PROPOSED ALTERATIONS & ADDITIONS WISEMAN RESIDENCE 63 MARINE PARADE AVALON BEACH

DWG 0319 1/5 SHIMDESIGN architectural design and drafting k2shimeld@gmail.com

MOD2023/0660

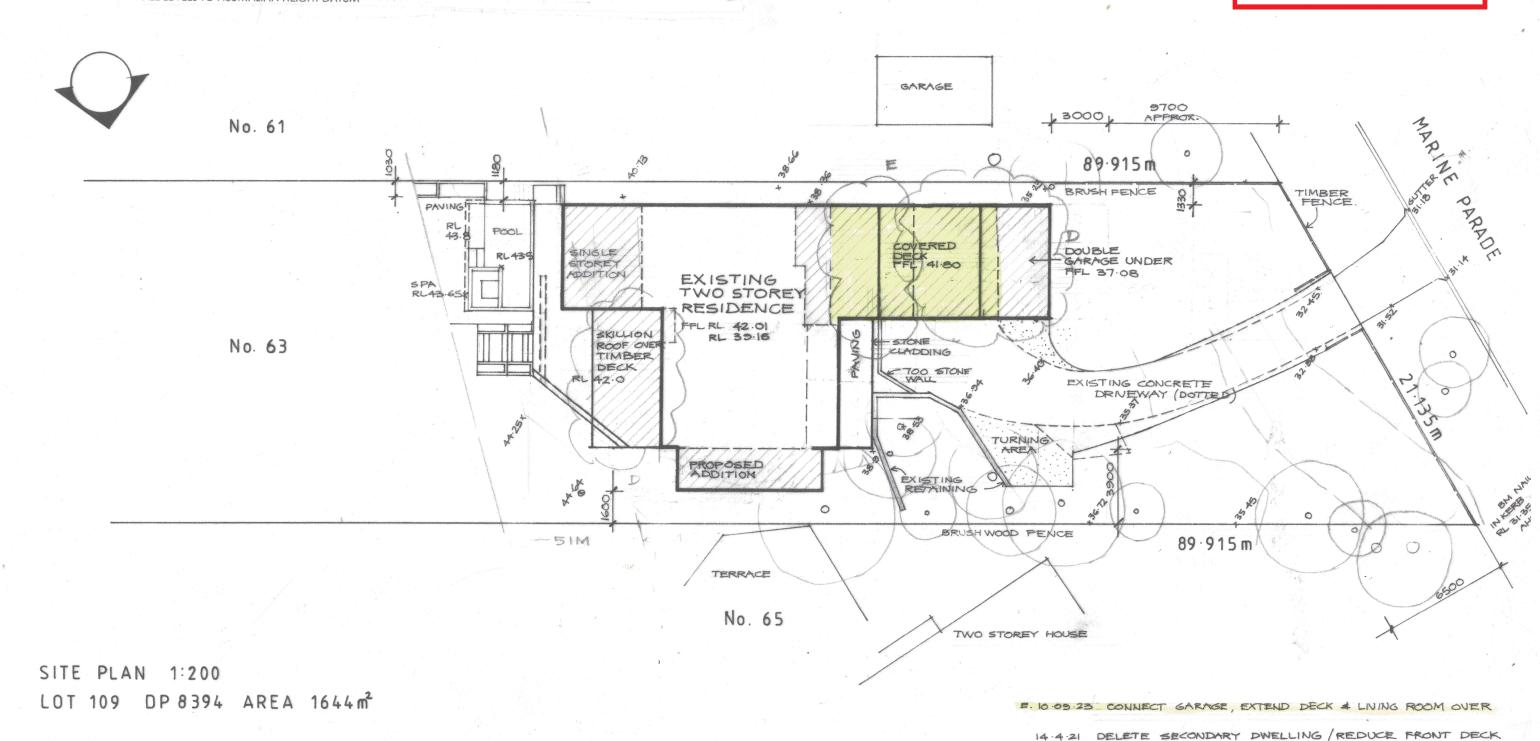
FREESTANDING GARAGE IN LIEU

10-12-14 MODIFICATION TO DA NO 263/14

PERGOLA IN LIEU.

12.5.20 POOL DECK DELETED/ CONDITIONS OF CONSENT FOR C.C.

24-11-14 REDUCE ROOF TO DECK DELETE CABANA ROOF
